**PRELIMINARY DRAINAGE REPORT  
FOR  
TAMLIN ROAD RV STORAGE-EXPANSION  
EL PASO COUNTY, COLORADO**

This should be Final  
Drainage Report

PPR2437

PCD File No.: **SF-24XX**

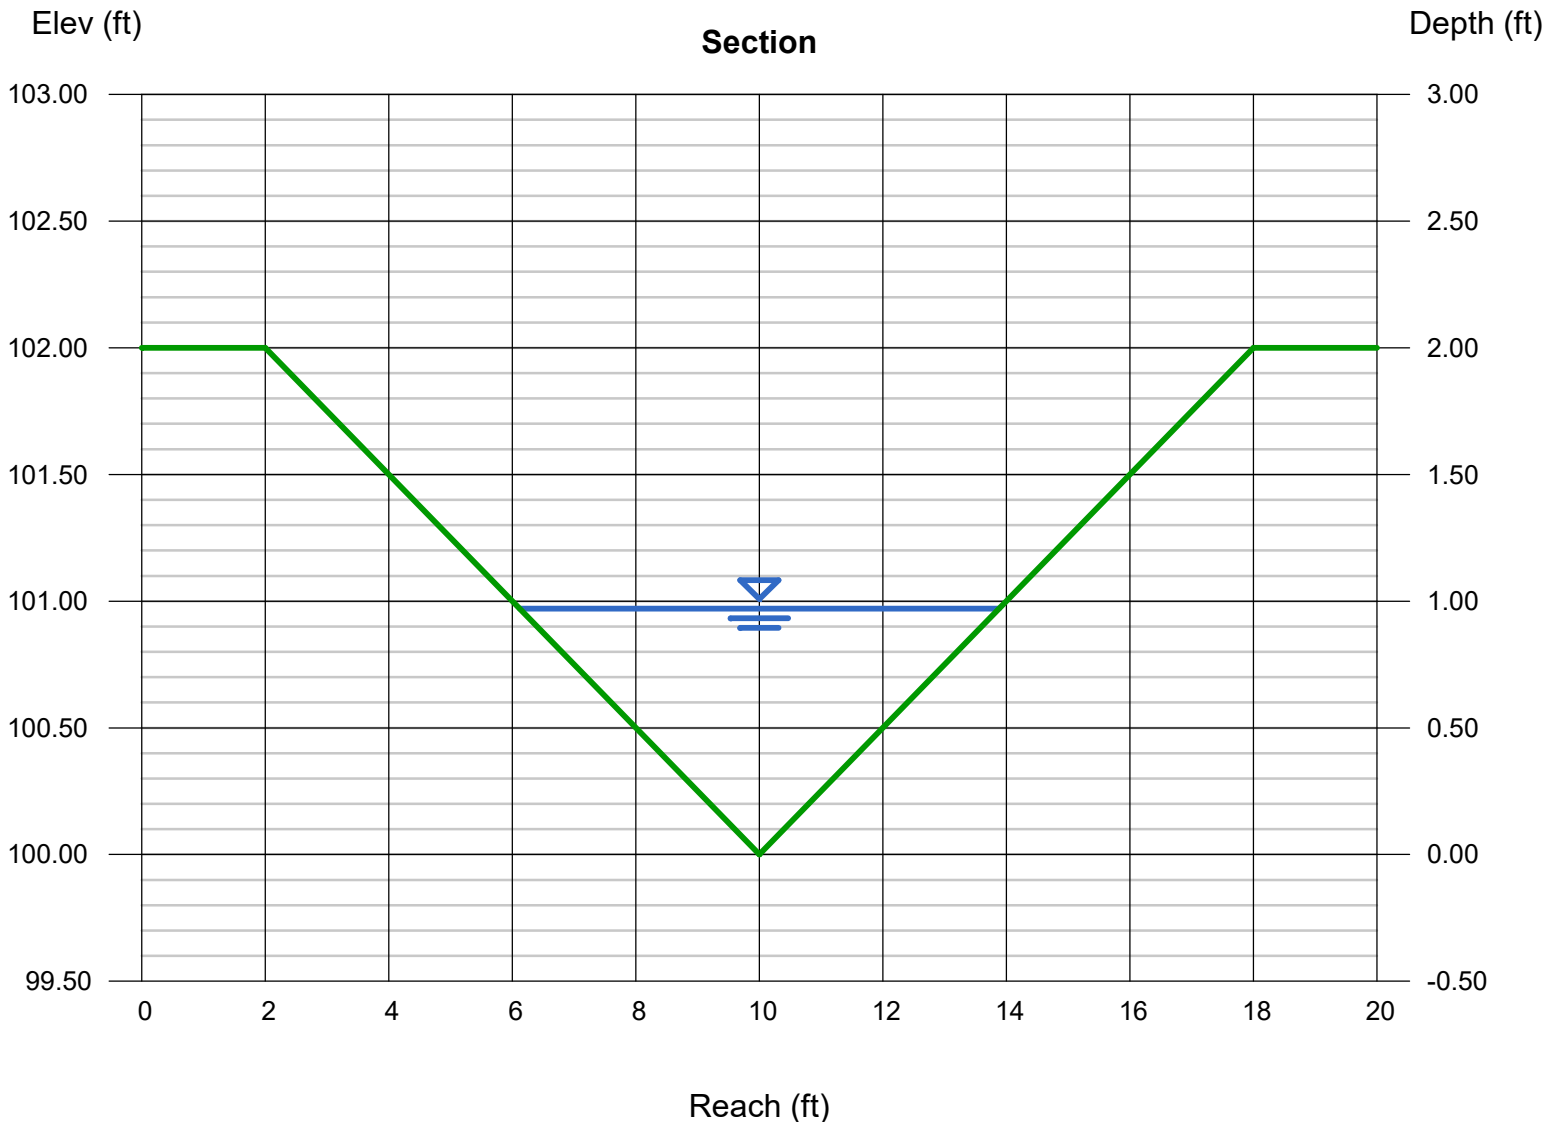
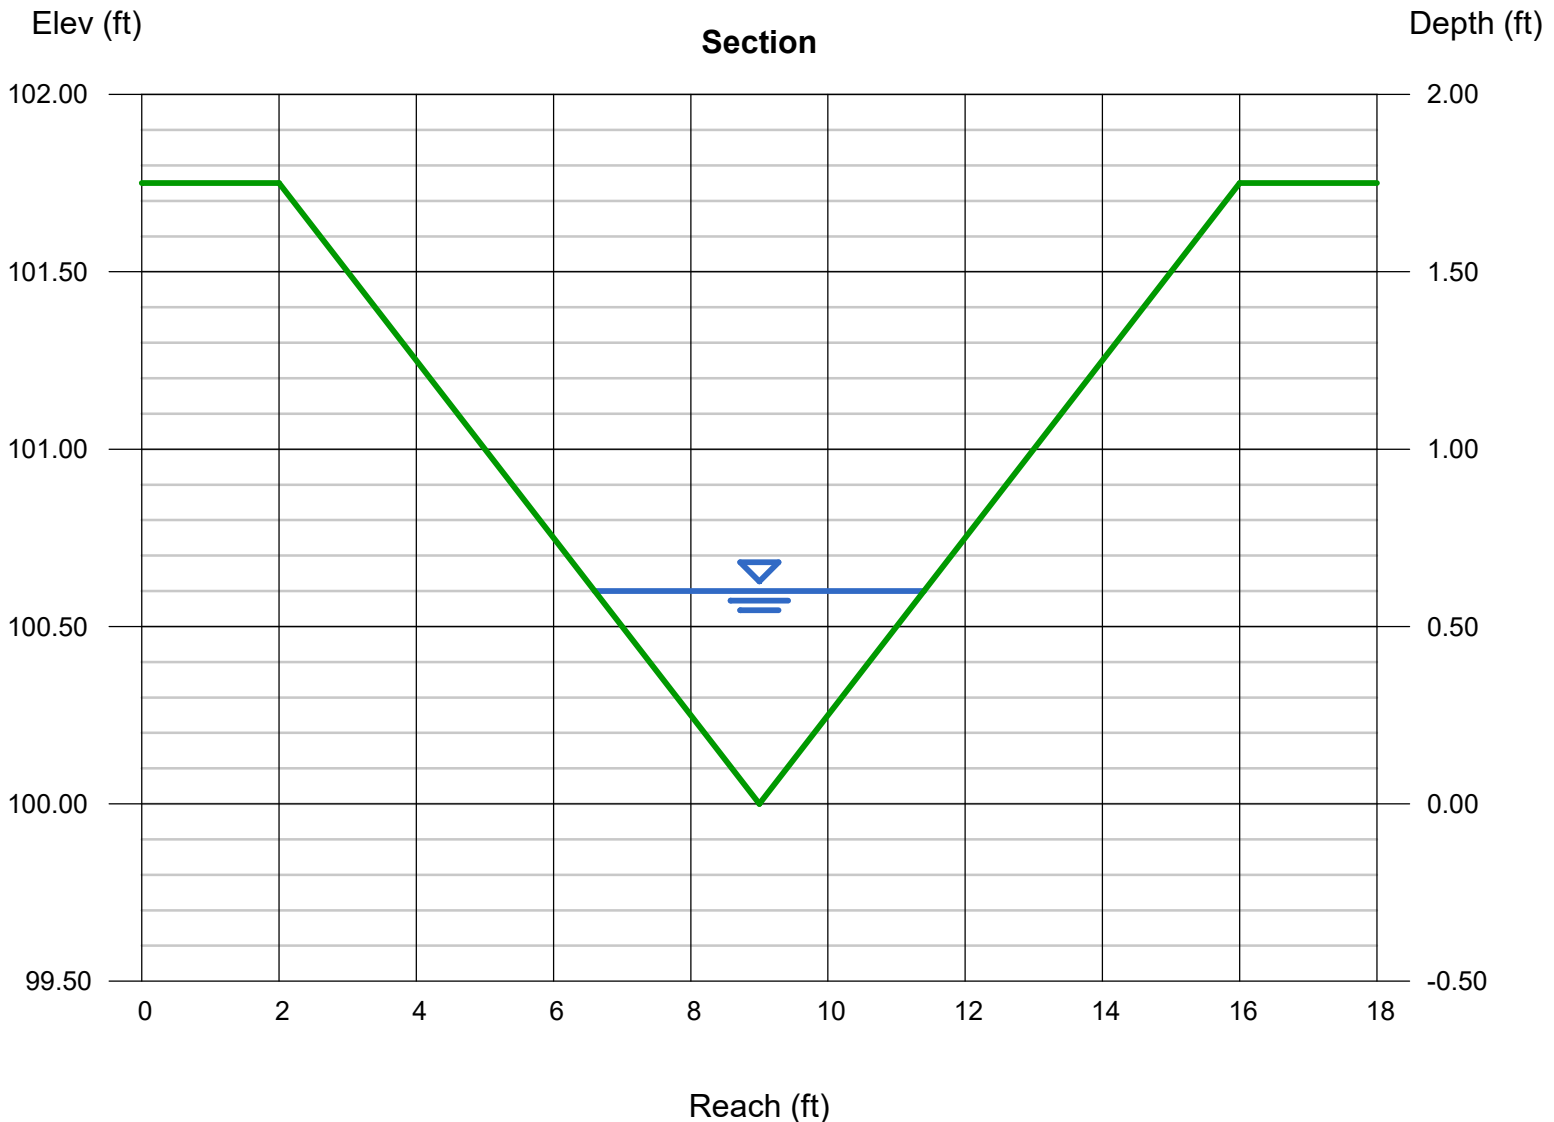
Provide calculations for: forebay, forebay notch, and trickle channel.

Please provide forebay design calculations. The minimum forebay volumes are shown on MHFD T-5 Table EDB-4. The minimum forebay volume should be 1-3% of the undetained peak 100-year discharge, depending on the tributary impervious acreage. And the forebay outlet should release 2% of the undetained peak 100-year discharge.

Per DCMv2 – Chap 4.2, trickle channel should at a minimum provide capacity equal to twice the release capacity at the upstream forebay outlet. Provide these calcs in the drainage report and revise plans as needed.

# DETENTION BASIN STAGE-STORAGE TABLE BUILDER

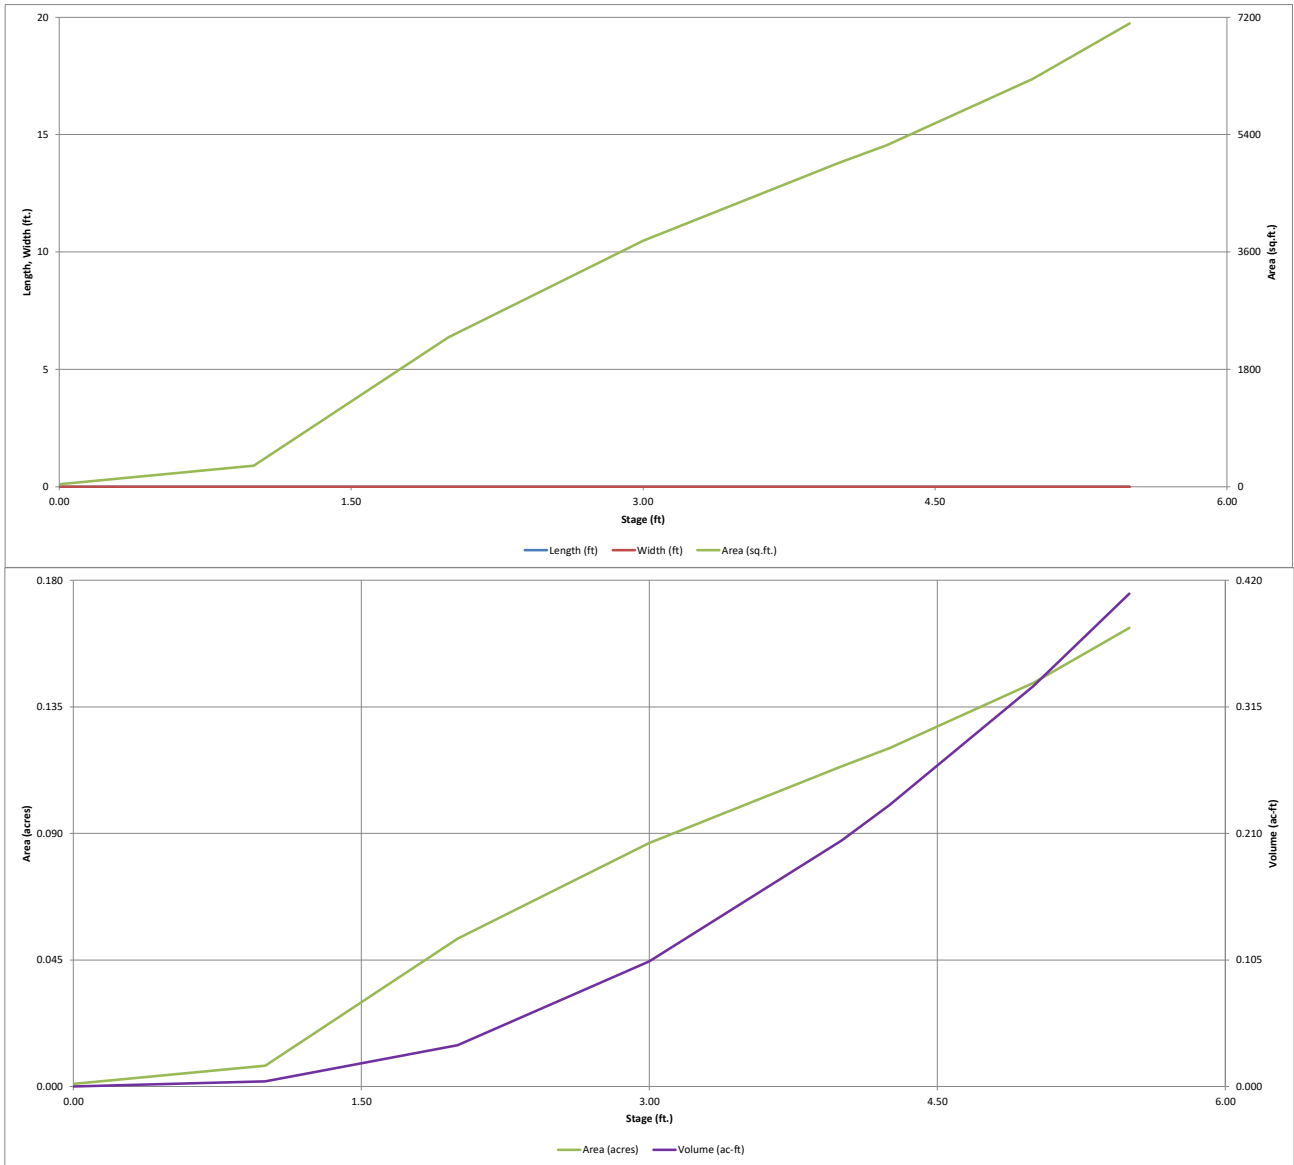
✓ = calcs match details in plans  
 X = calcs do not match details in plans

# TAMLIN ROAD RV & BOAT STORAGE PROPOSED DRAINAGE MAP

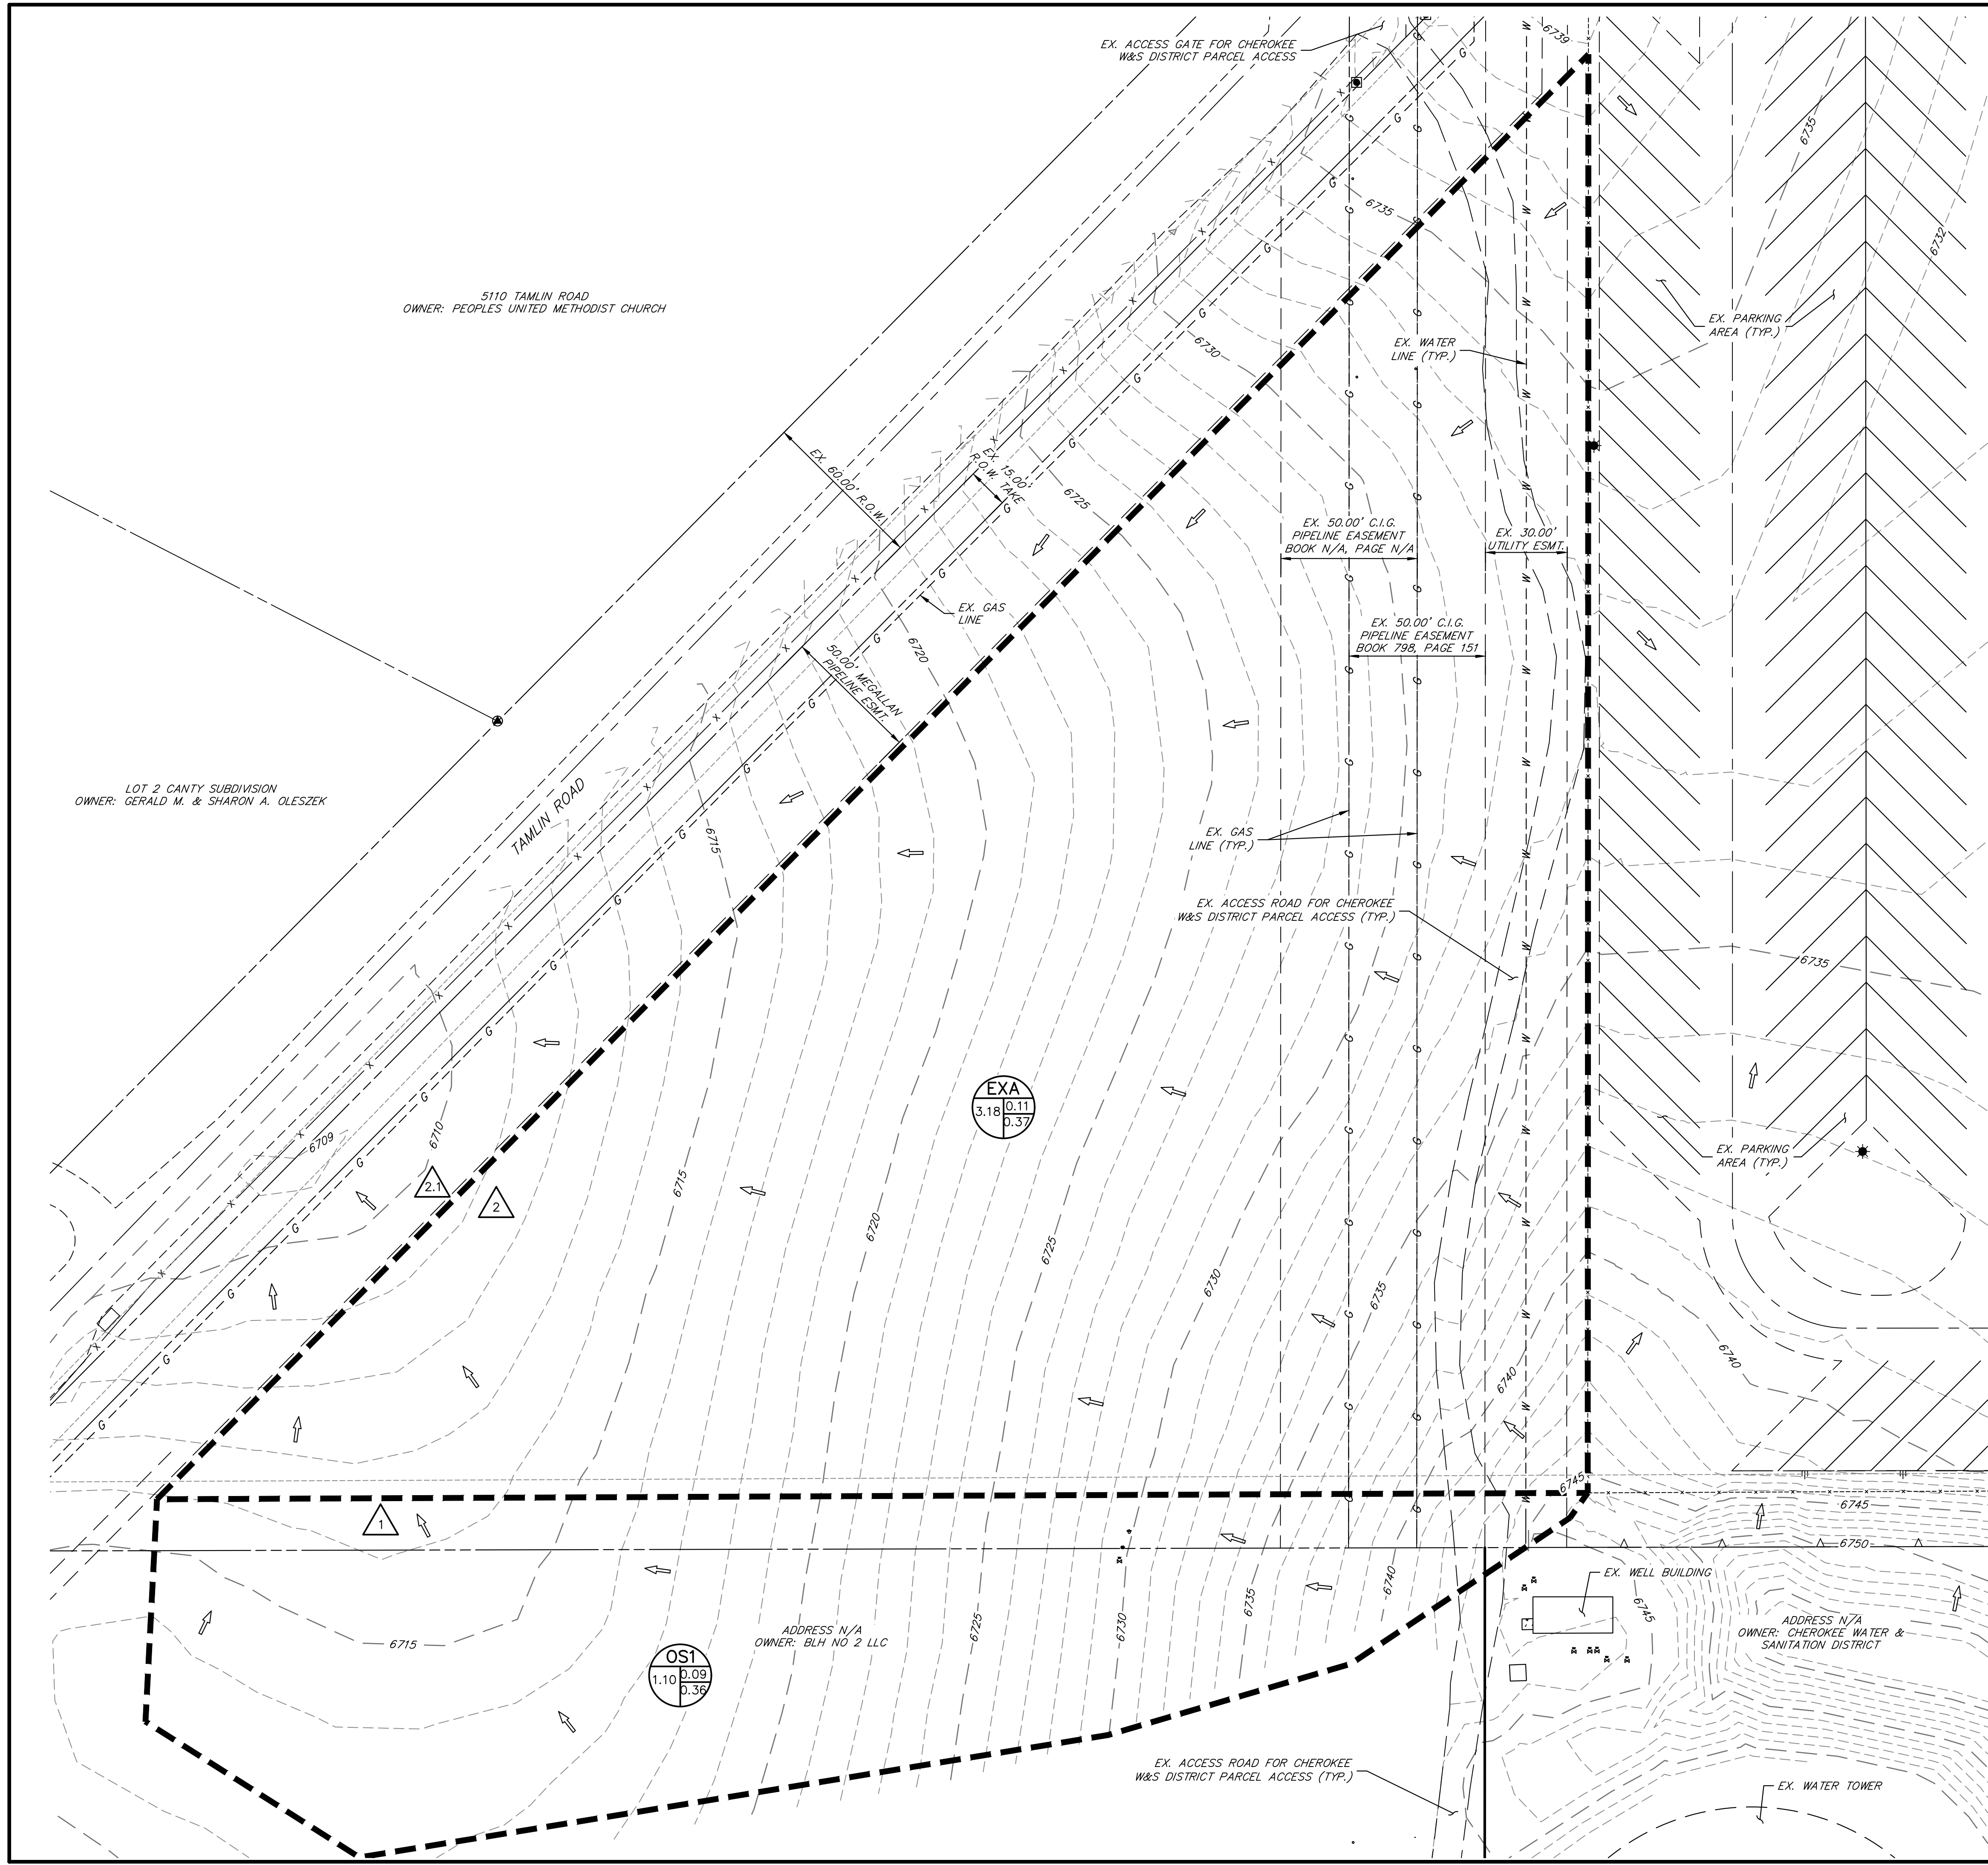
Add details about prior drainage report for this property under PCD File PPR1945
